Jacfin Pty Ltd C/O Allens
Deutsche Bank Place
126 Phillip St, Sydney NSW 2000
Attention Bill McCredie

The Next Generation - Proposed Waste to Energy Facility (SSD 6236)
Odour Impact Assessment

Appendix B – GHD’s 10 March 2017 technical review

Energy from Waste Facility - Odour Review Addendum

Figure 1

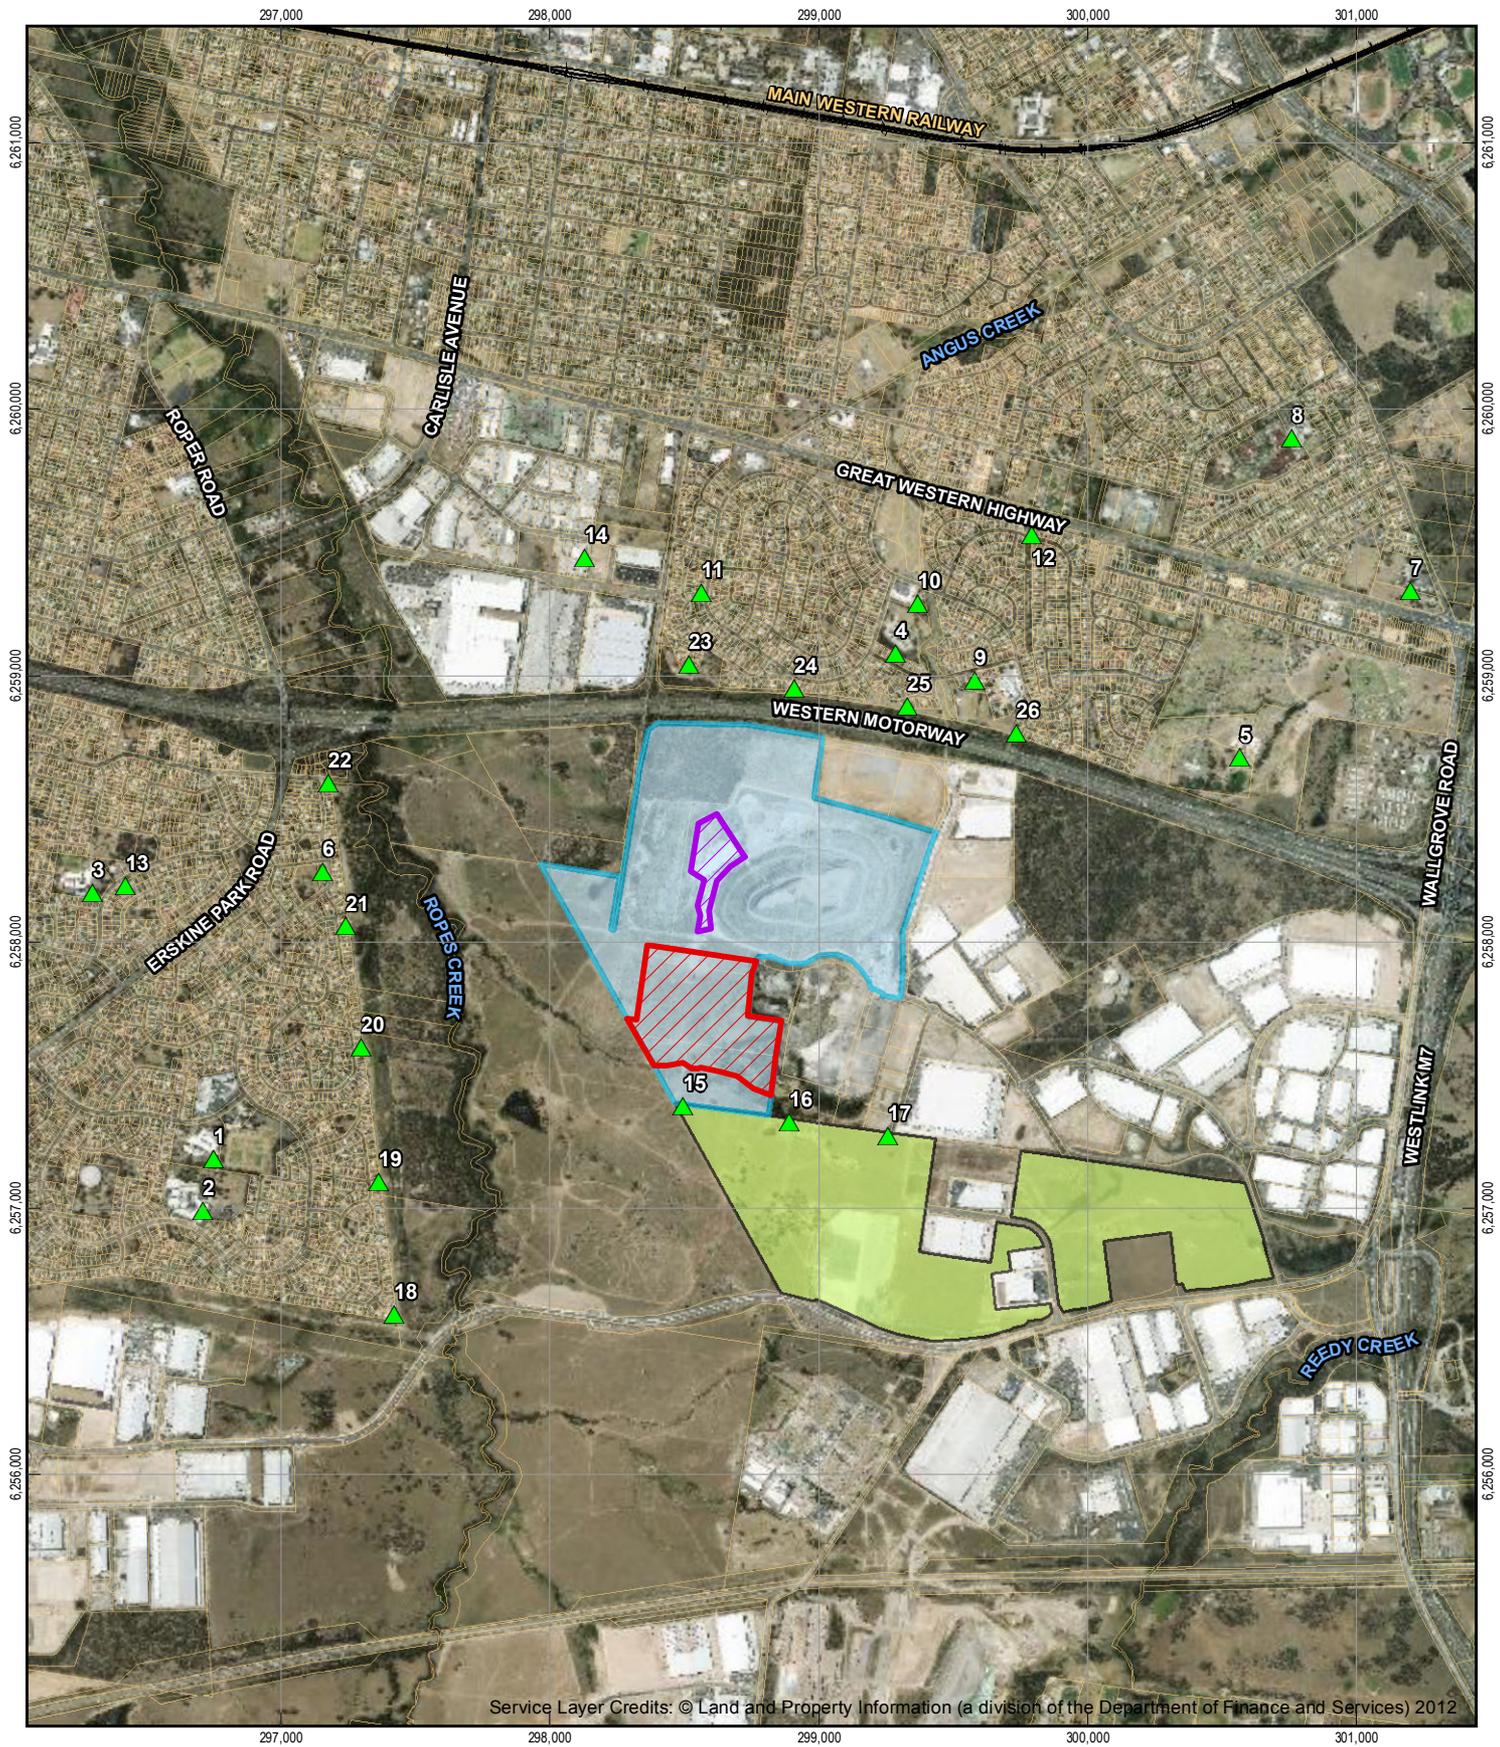
A map showing the location of the Next Gen Facility, Genesis Facility and sensitive receptors is shown in Figure 1. Additional receptors have been included in the model as the nearest receptors to the site which were not included in the EIS Odour Assessment.
